HISTORIC AND DESIGN REVIEW COMMISSION

November 18, 2020

HDRC CASE NO: 2020-415
ADDRESS: 219 ADAMS ST
216 WICKES
218 WICKES
LEGAL DESCRIPTION: NCB 942 BLK 1 LOT 5
ZONING: RM-4,HS
CITY COUNCIL DIST.: 1
DISTRICT: King William Historic District
LANDMARK: Individual Landmark
APPLICANT: Derek Keck/Fisher Heck, Inc. Architects
OWNER: Don Fry/RIVER CITY LOANS INC
TYPE OF WORK: Dismantling and partial reconstruction of primary structure addressed 216-218 Wickes, site modifications
APPLICATION RECEIVED: September 18, 2020
60-DAY REVIEW: Not applicable due to City Council Emergency Orders
CASE MANAGER: Stephanie Phillips

1. Dismantle the primary structure located at 216/218 Wickes.
2. Partially reconstruct the primary structure with a smaller footprint and modified interior elevations. The primary (west) and one secondary (north) façade will be reconstructed in-kind utilizing salvaged materials from the original structure.
3. Perform site modifications.

WEST ELEVATION - GARAGE

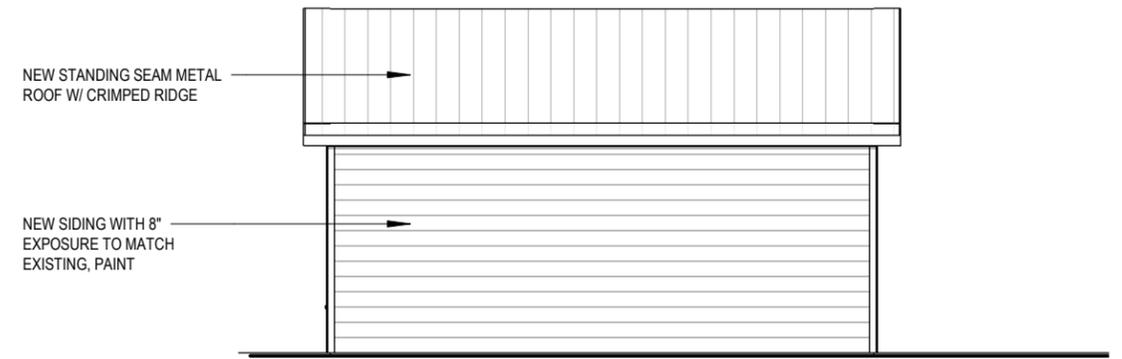
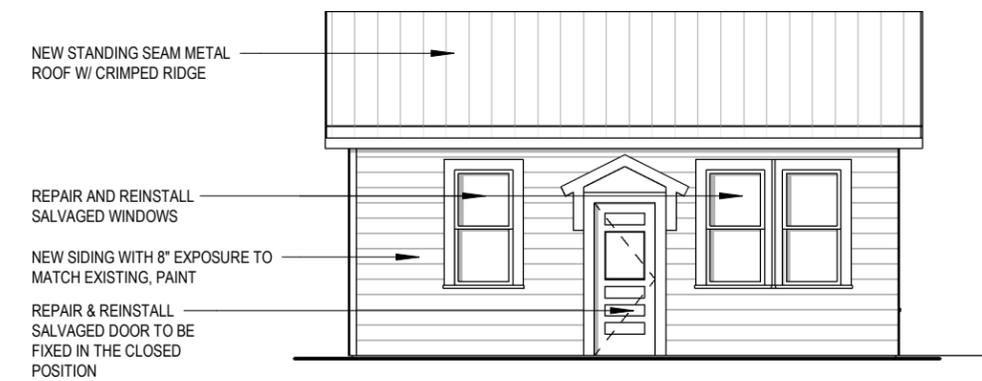
- 2d. ROOF – The applicant has proposed front-facing gable roof form with two low-sloping shed roofs on either side of the front and rear facades. The overall roof form is to be reconstructed in-kind. The roof will be standing seam metal. According to the Guidelines, new roof forms should be similar to the primary structure or architecturally appropriate for the style of the home. Staff finds the proposal appropriate.

- 2e. FENESTRATION – The applicant has proposed to reconstruct the existing fenestration on the front (west) and north facades as closely as possible, utilizing salvaged windows and doors and trim. The rear elevation will feature two single-bay overhead garage doors and two pedestrian doors. The south elevation will be blank due to its extremely close proximity to the adjacent primary structure. Staff finds the overall proposal appropriate.

- 2f. MATERIALS – The applicant has proposed to use the following materials salvaged from the existing structure: windows, doors, gable louvers, and some siding where feasible. Any new materials introduced to the site as a result of an addition must be compatible with the architectural style and materials of the original structure. Staff generally finds the proposed materials appropriate with the stipulations listed in the recommendation.

- iii. That the applicant installs a standing seam metal roof featuring panels that are 18 to 21 inches wide, seams that are 1 to 2 inches high, a crimped ridge seam, and a standard galvalume finish. Panels should be smooth without striation or corrugation. Ridges are to feature a double-munch or crimped ridge configuration; no vented ridge caps or end caps are allowed. An on-site inspection must be scheduled with OHP staff prior to the start of work to verify that the roofing material matches the approved specifications. All chimney, flue, and related existing roof details must be preserved.

- iv. That the applicant submits final material specifications for all new materials to be used, including siding, windows, roofing, foundation elements, and more, to staff for review and approval prior to the issuance of a Certificate of Appropriateness. If any windows or doors are deemed deteriorated beyond repair upon the start of dismantling, the applicant is required to submit evidence of that effect to staff for review and approval and submit specifications for new fully wood doors and windows that meet the following requirements: That the applicant submits final material specifications for the fully wood windows. Clad windows of any kind are not allowed on the historic structure. Windows should feature an inset of two (2) inches within facades and should feature profiles that are found historically within the immediate vicinity. Meeting rails must be no taller than 1.25" and stiles no wider than 2.25". There should be a minimum of two inches in depth between the front face of the window trim and the front face of the top window sash. This must be accomplished by recessing the window sufficiently within the opening or with the installation of additional window trim to add thickness. Window trim must feature traditional dimensions and an architecturally appropriate sill detail. Window track components must be painted to match the window trim or be concealed by a wood window screen set within the opening.
